6.1 **1 HOLROYD COURT ST KILDA EAST - PDPL/01004/2021**
LOCATION/ADDRESS: 1 HOLROYD COURT ST KILDA EAST VIC 3183
EXECUTIVE MEMBER: KYLIE BENNETTS, GENERAL MANAGER, CITY GROWTH AND DEVELOPMENT
PREPARED BY: JEREMY NEWLAND, SENIOR URBAN PLANNER
DONNA D'ALESSANDRO, MANAGER CITY DEVELOPMENT

- 1.1 To consider and determine Planning Application PDPL/01004/2021 for the partial demolition of an existing dwelling and buildings and works on a lot over 500m² in a Heritage Overlay.

Fig 5 – Roof/STORM calc plan

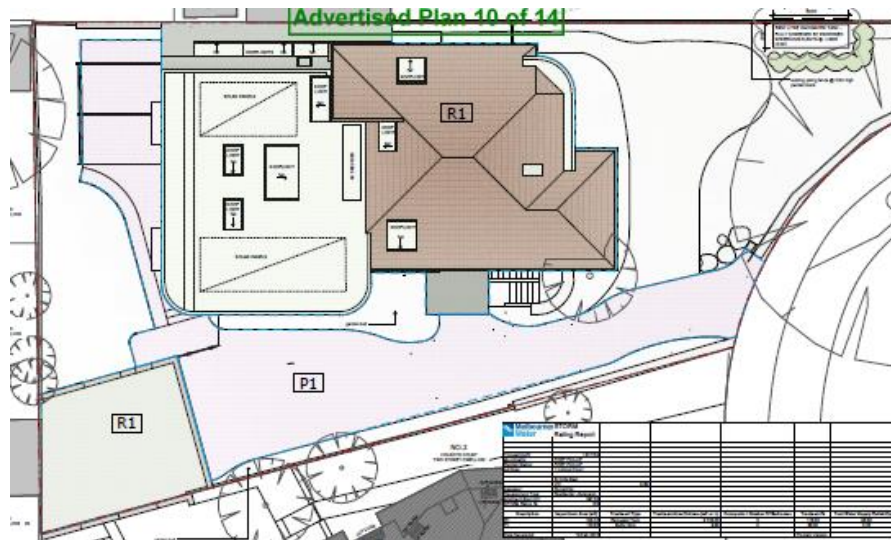
This acceptability also relates to matters concerning the letterbox, and the location of services (generally shown on TP104 - Roof/Storm calc plan).

- a) Detail as to the materiality, width and steel profile of the proposed replacement front façade windows to be shown at an increased scale, to ensure the same as those as existing.
- b) The sections of original heritage fabric to be retained, to be noted as cleaned and repainted.
- c) The proposed location of the rainwater tank to be lower in height than the northern boundary fence and conclusively screened by appropriate-height vegetation.
- d) Inclusion of the 9.6m² buffer strip to be shown on the Roof/STORM Calculation Plan (TP104), along with full compliance with the Water Sensitive Urban Design as outlined in Condition 8.
